CITY PLAN COMMISSION REPORT

Mazuma Credit Union on North Oak

#4 CD-CPC-2020-00191
Rezoning to MPD

Plan Conditions, Corrections, & Recommendations Report

MPD PLANS	
MAZUMA CREDIT UNION	
LOT 2 QUICKTRIP STORE 221R	
KANSAS CITY, CLAY COUNTY, MO	
SITE PLAN	
LKC 19-7310	GRUBBS 2021
C3.1

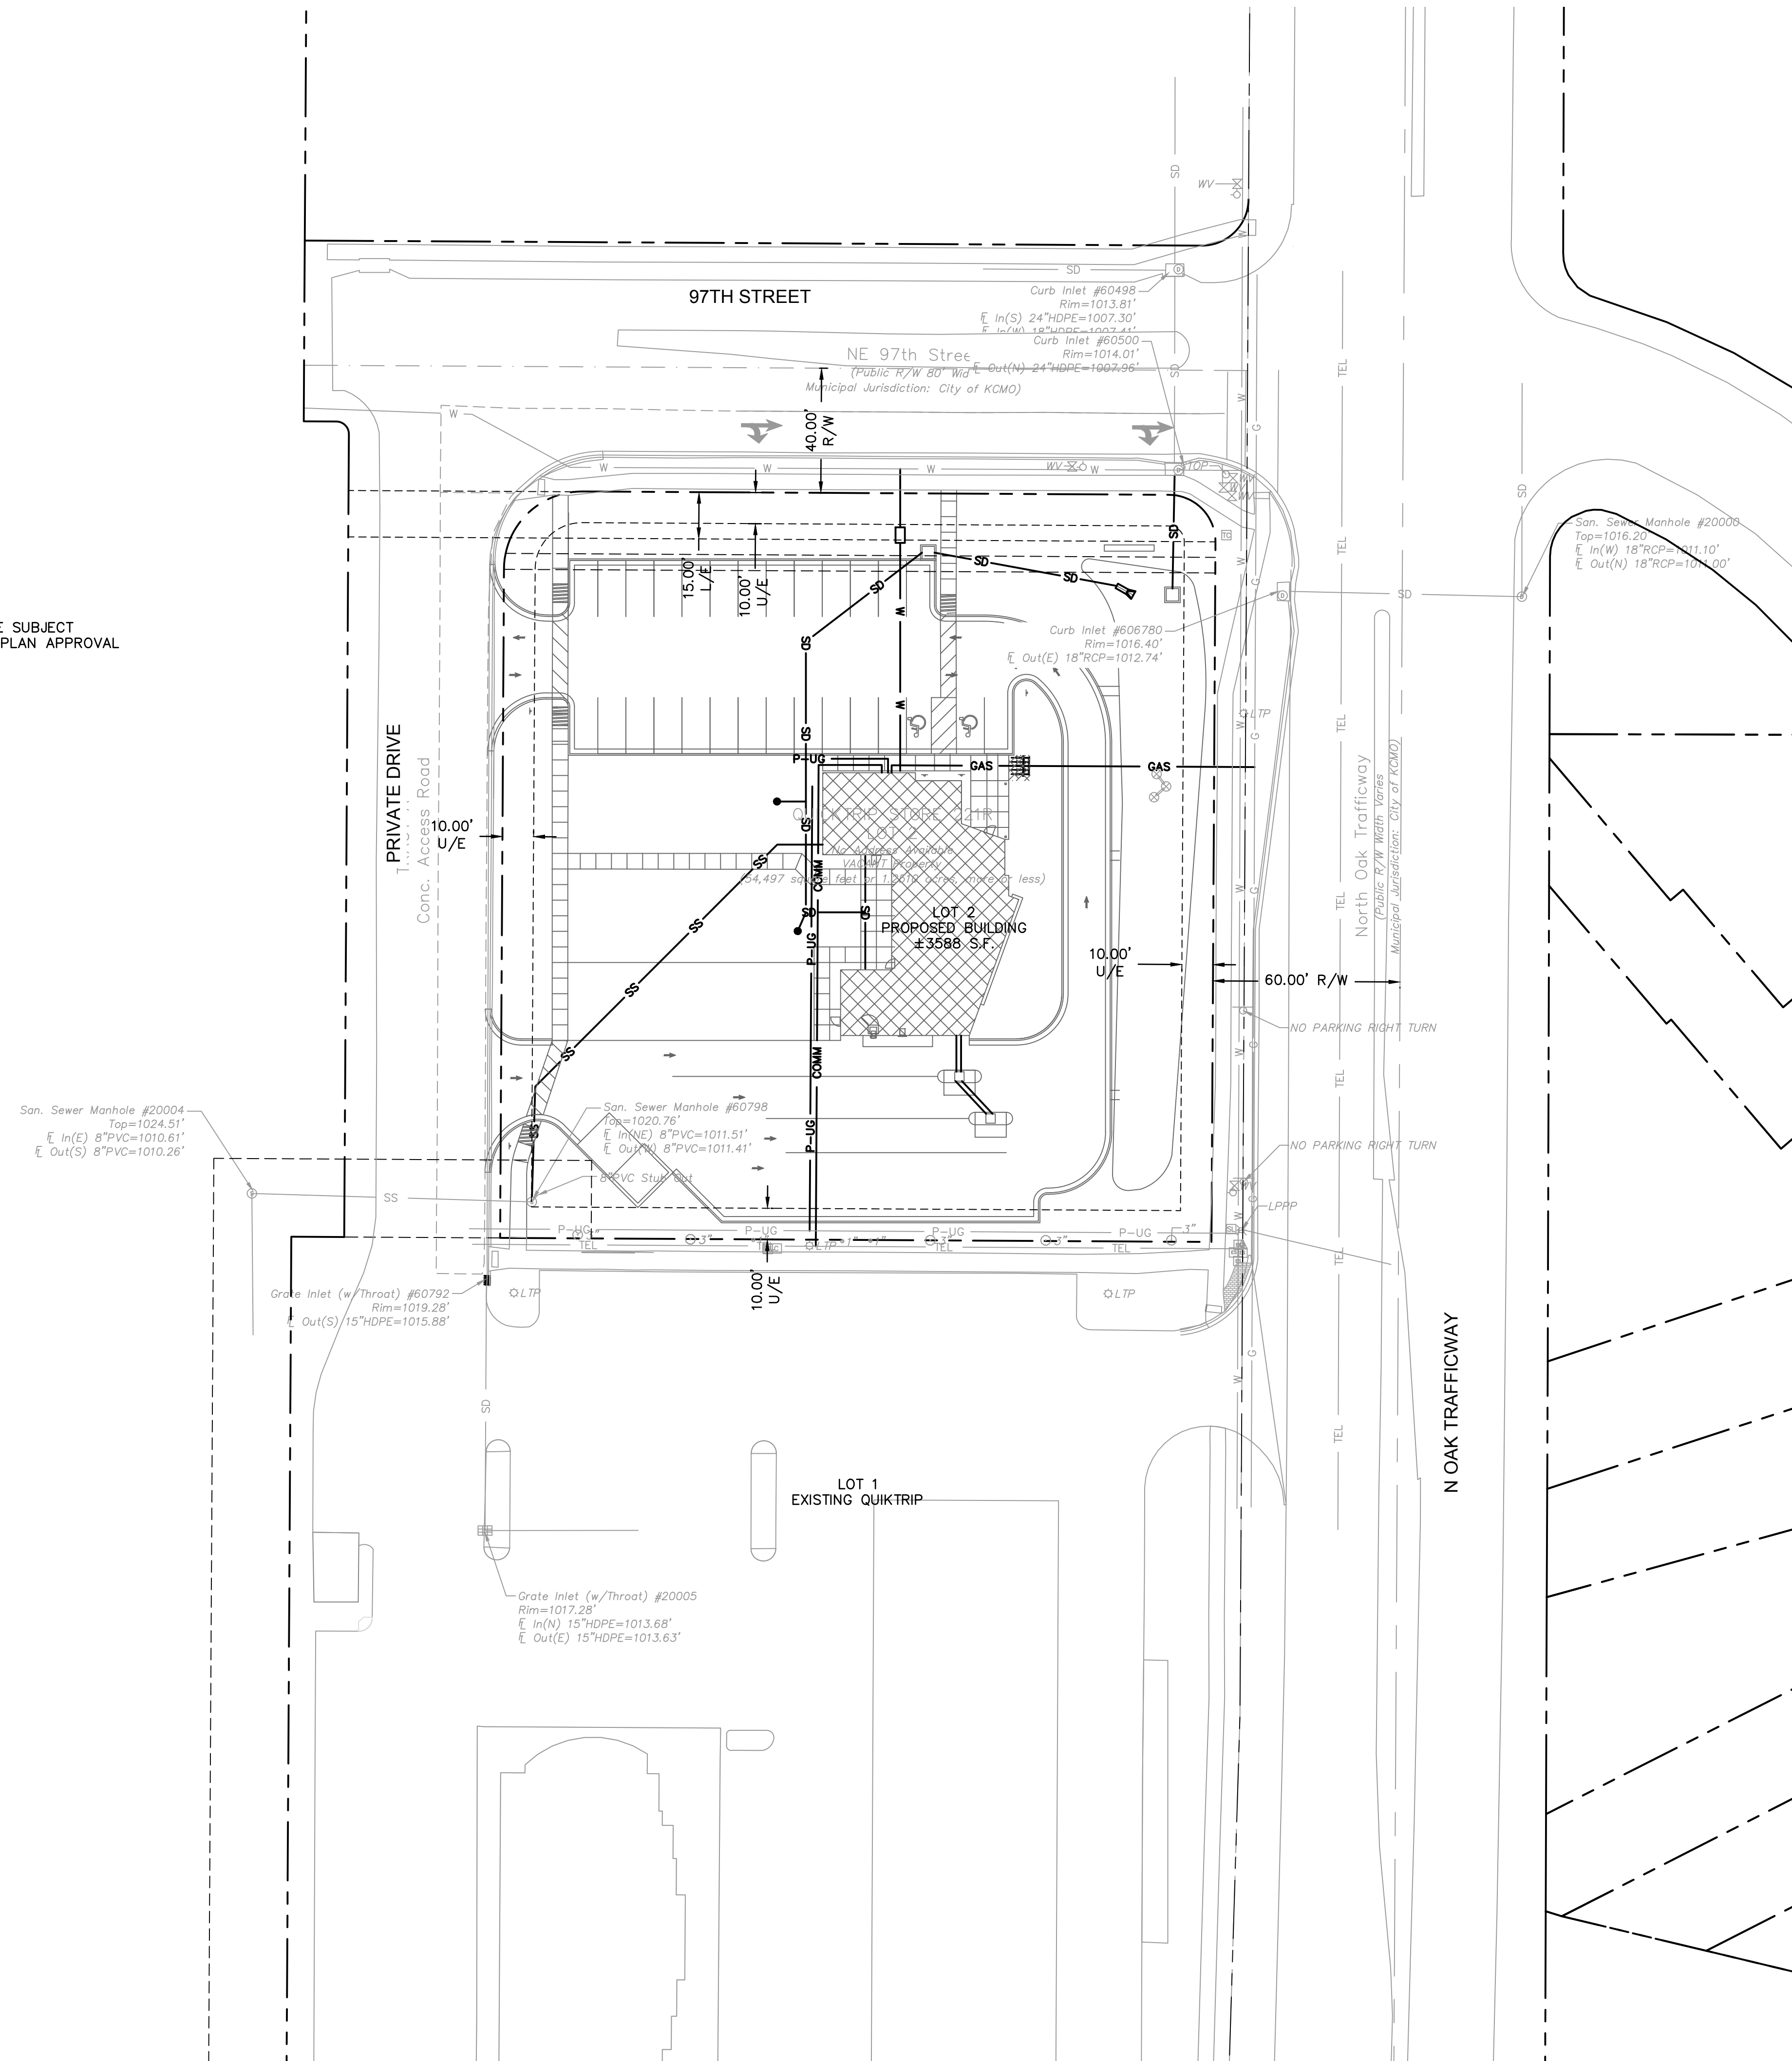
The plan, as proposed, is in general conformance with the applicable plans. Access to the site is provided off NE 97th Street, which leads to the northern parking lot, as does the first driveway from the private drive on the western side of the sit. The second drive provides the only access to the drive-through lane; clear signage will be pivotal in directing drivers on the correct entrance to use for parking versus drive-through use.

Additionally, pedestrian safety on the site as well as connectivity to the QuikTrip site to the south needs improvement, as included in the plan corrections.

16. The developer shall label the driveway widths and radii prior to certificate of occupancy. Values shall comply with Public Works Standard Detail D-3. (3/04/2021)

C:\Users\m004\Documents\2021\General Model\Submittal\A-6.1.dwg
12/18/2020 MPD SUBMITTAL
EXTERIOR ELEVATIONS
LKC 19-7310 GRUBBS 2021
A-6.1

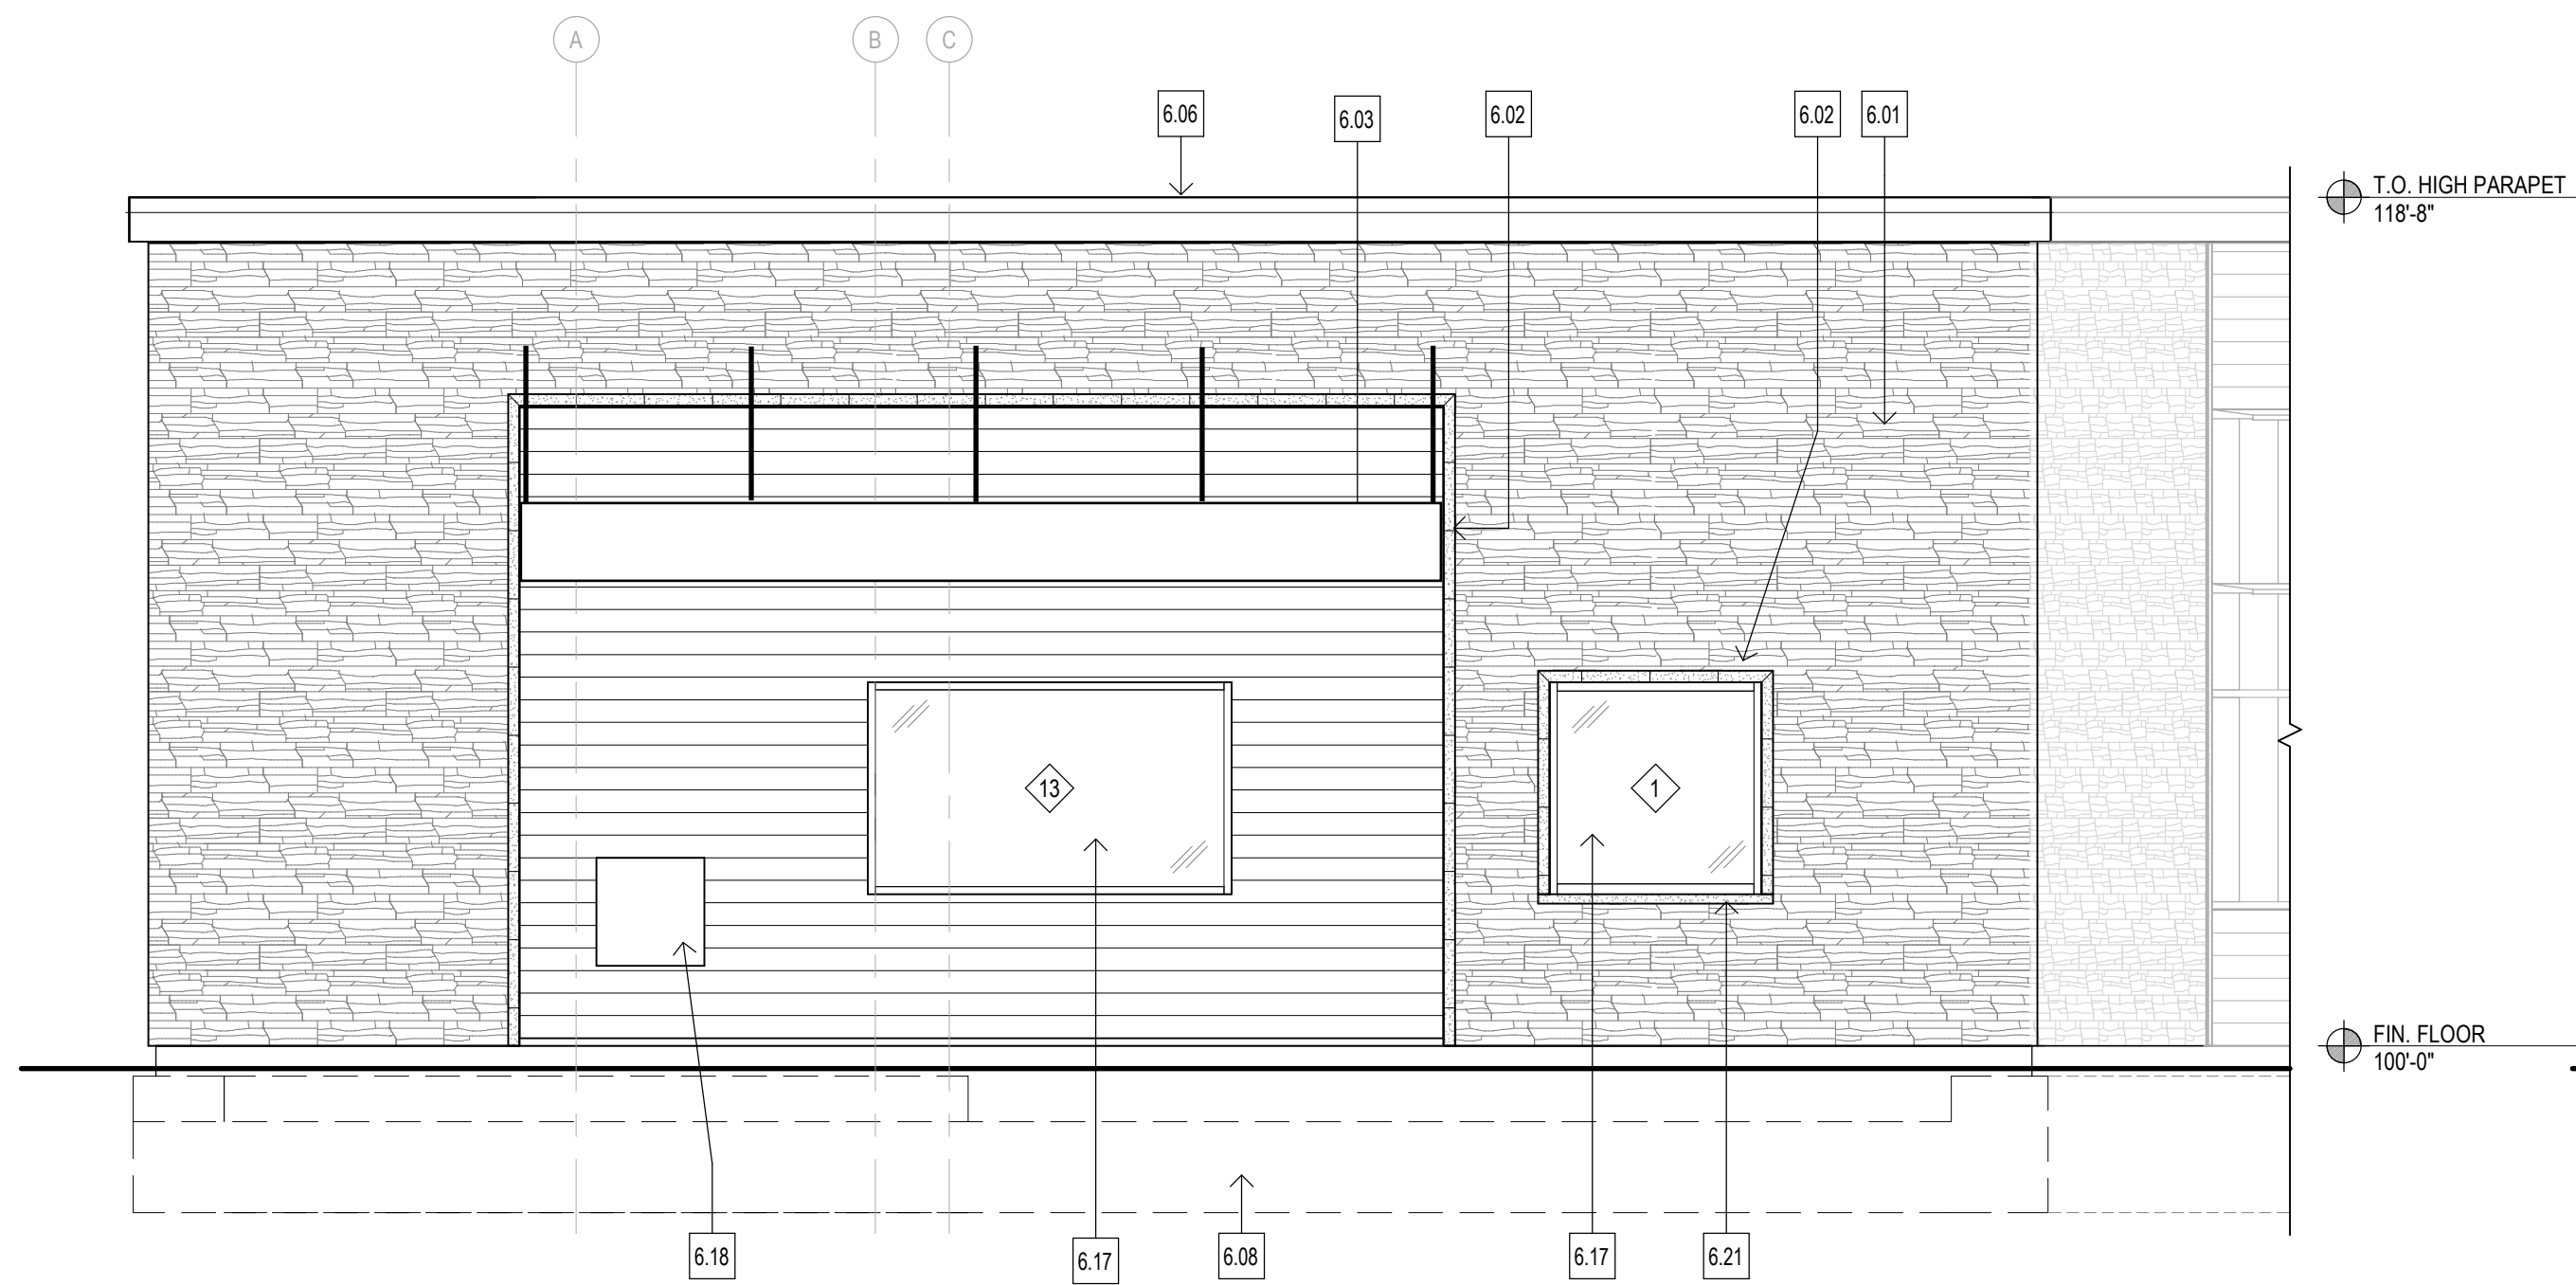
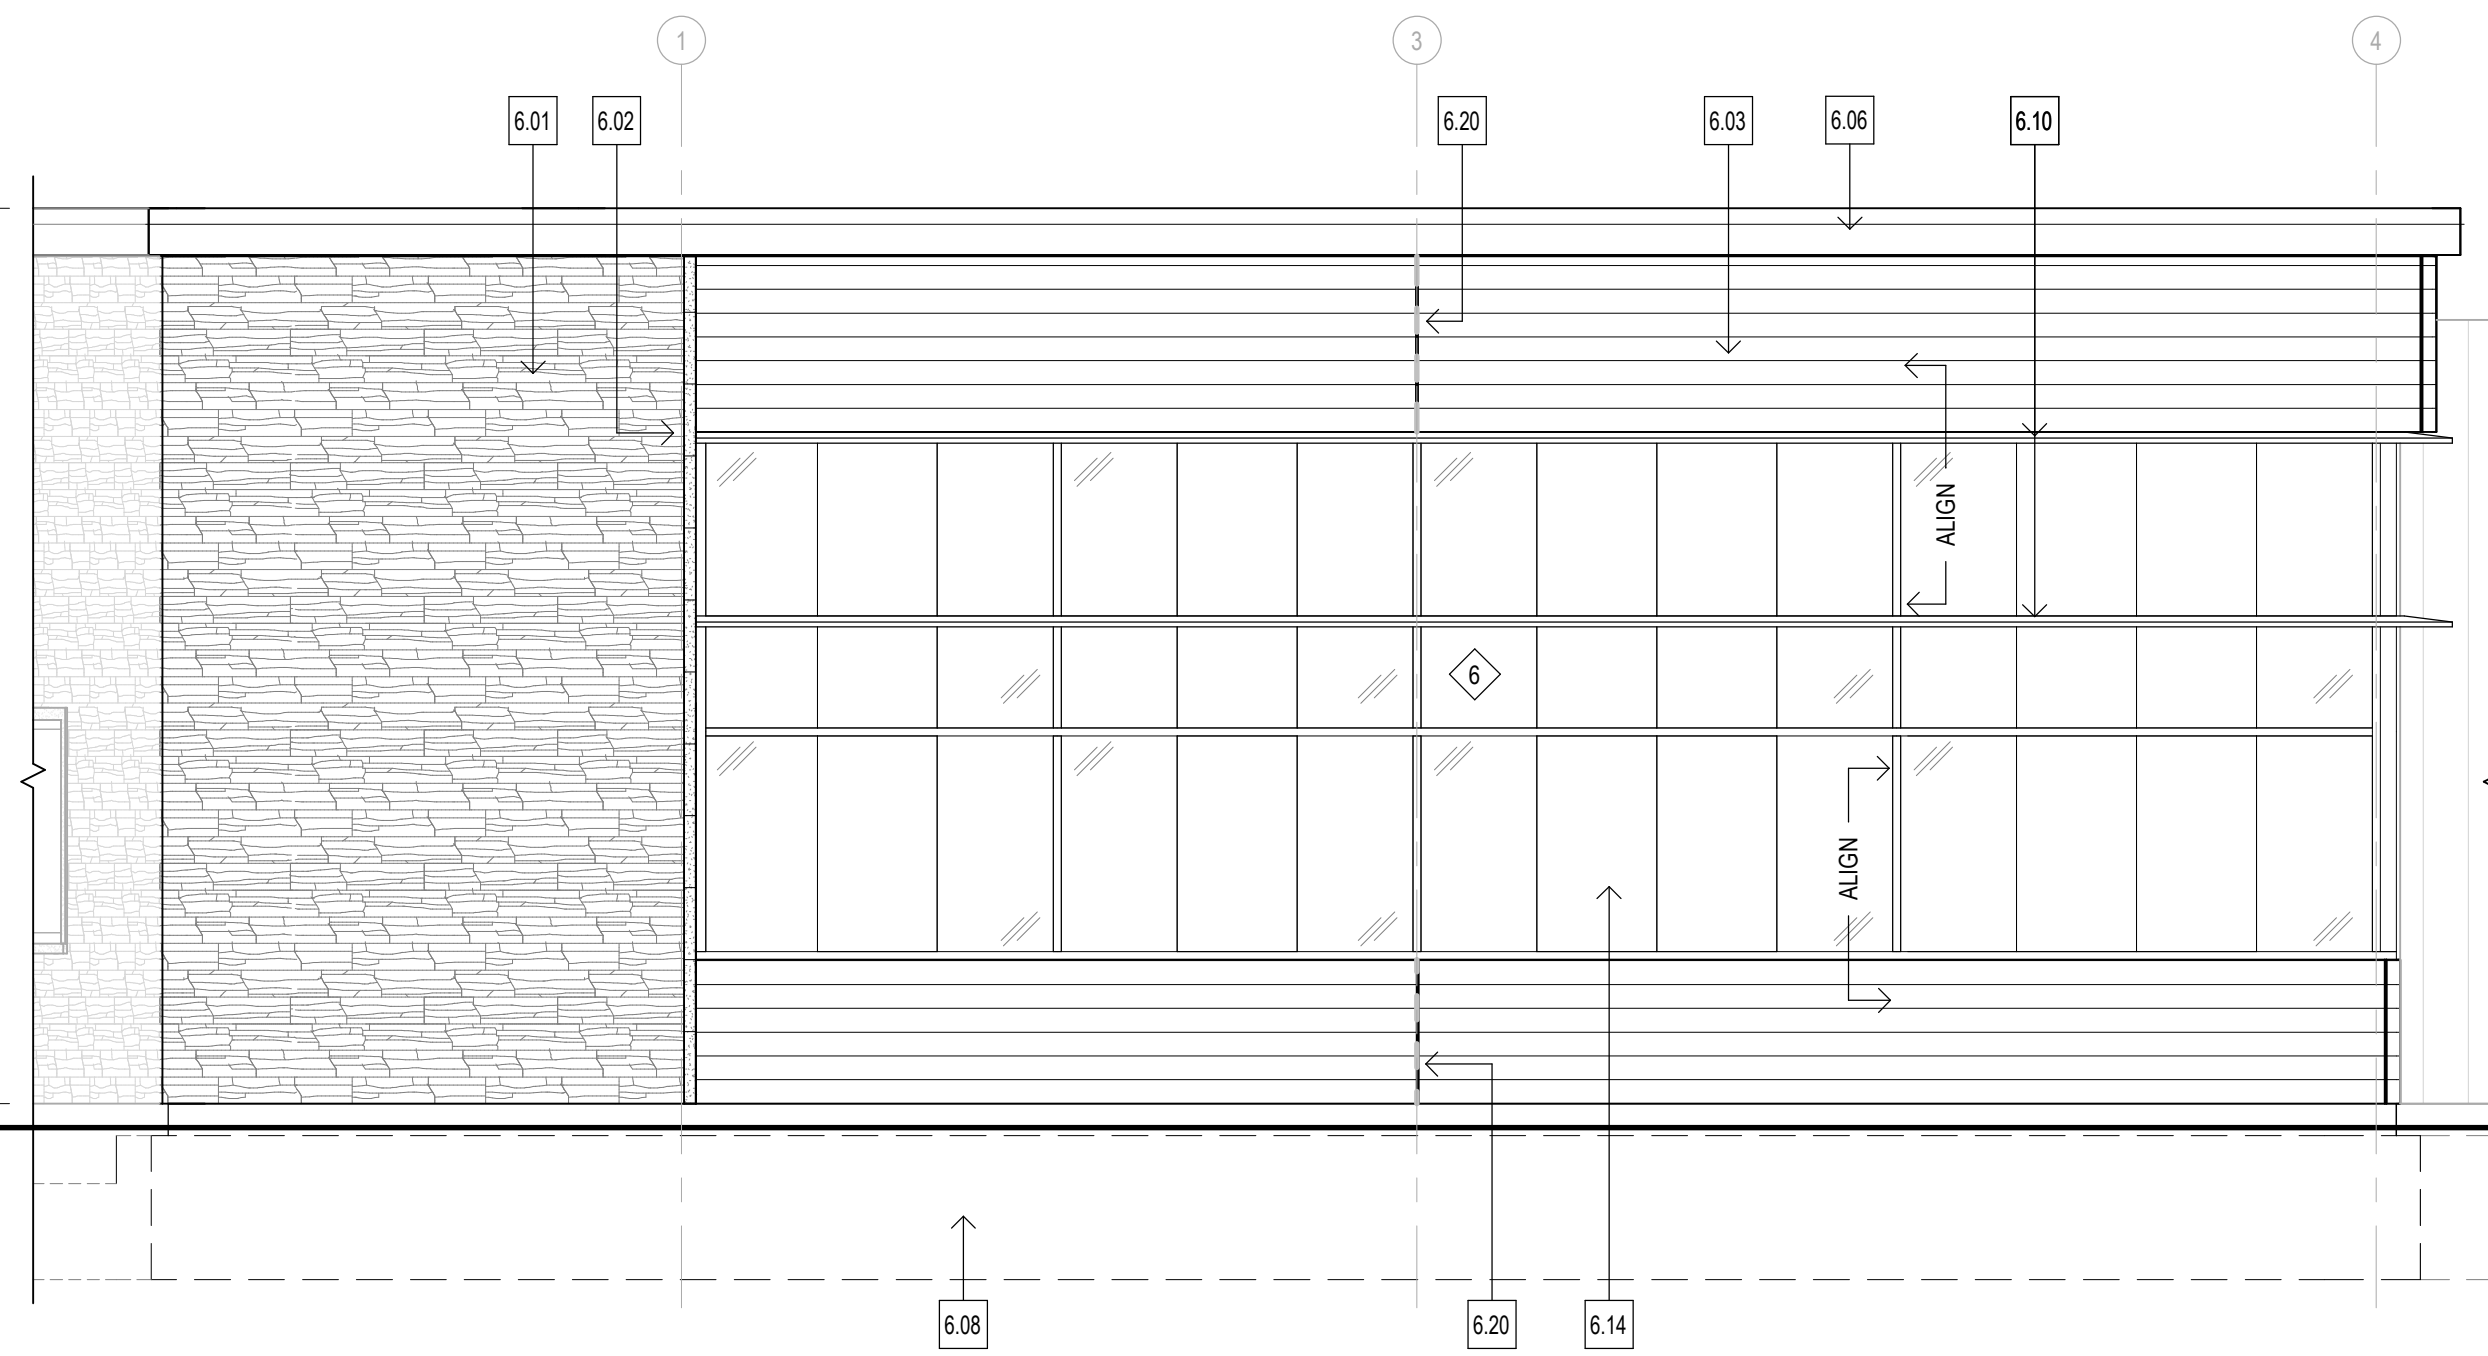
The building elevations include appropriate use of stone, wood, and metal panel accents; however, staff has not received complete drive-through designs and will need such to ensure compliance with the standards of 88-340.
